ENGINEERING CHANGE NOTICE NO.

04556

DWG NO. 647.3900

DWG TITLE: DEFLECTORS

SHEET 5, ZONE C6 IS:

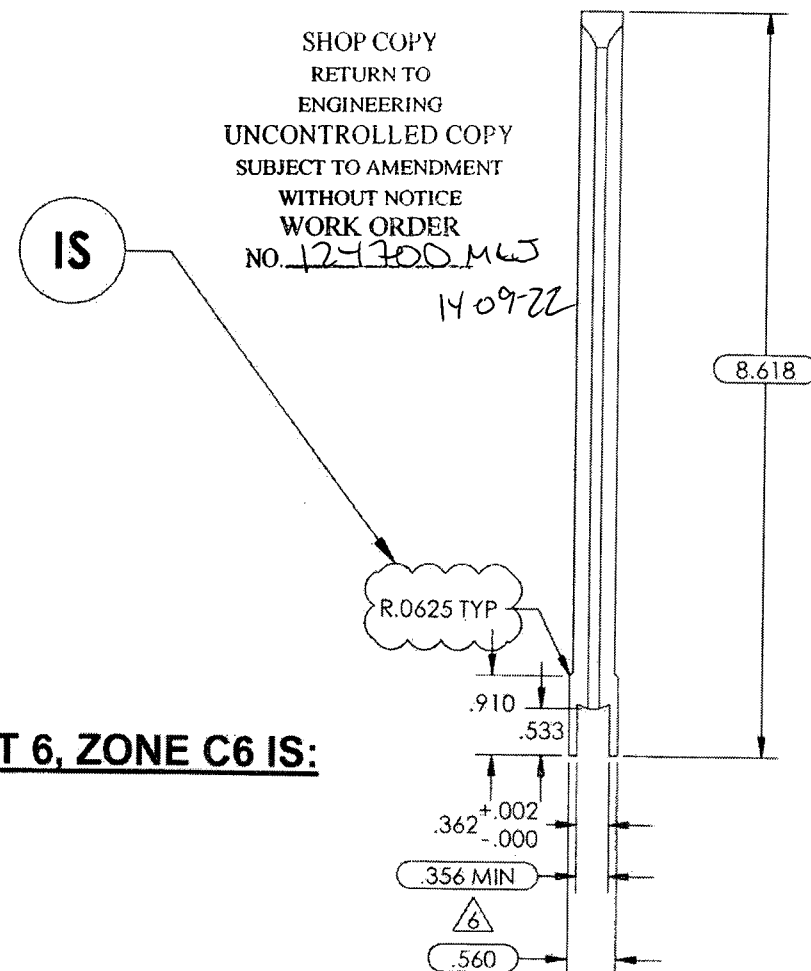
REASON: DIMENSION CHANGE

SHEET 6, ZONE C6 IS:

DEFLECTORS

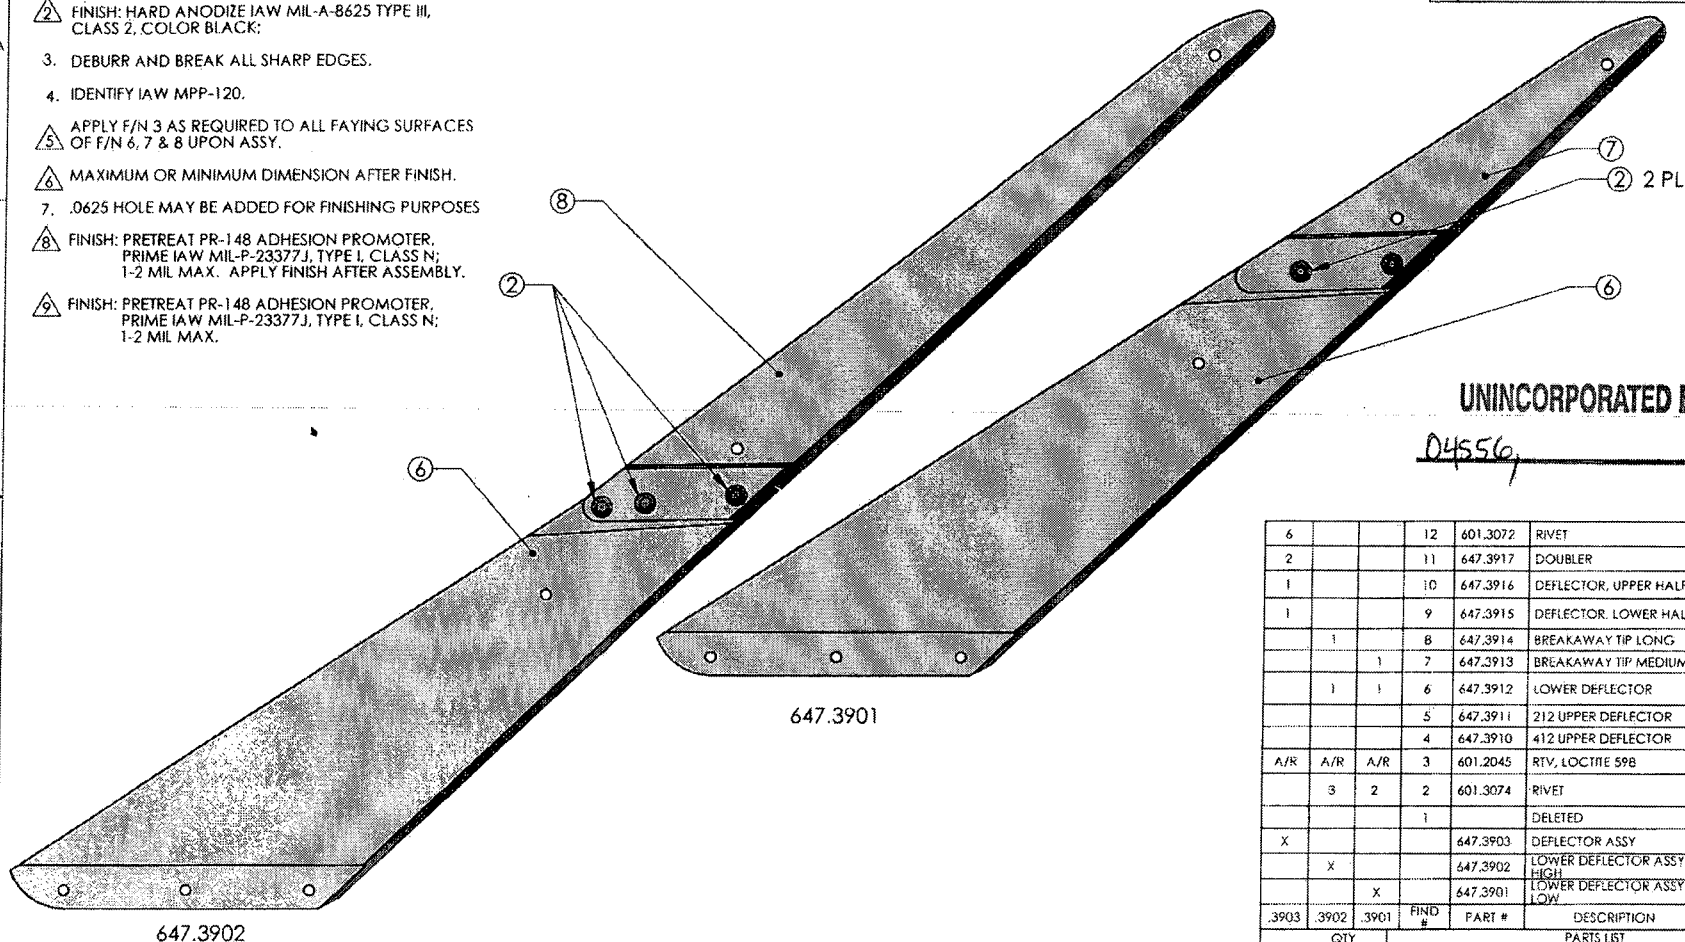
I think you had look at one similar not too long ago. 647.3902, the rivet has to change from -12 to a -14.

Is this acceptable?

The rivet length change is acceptable.
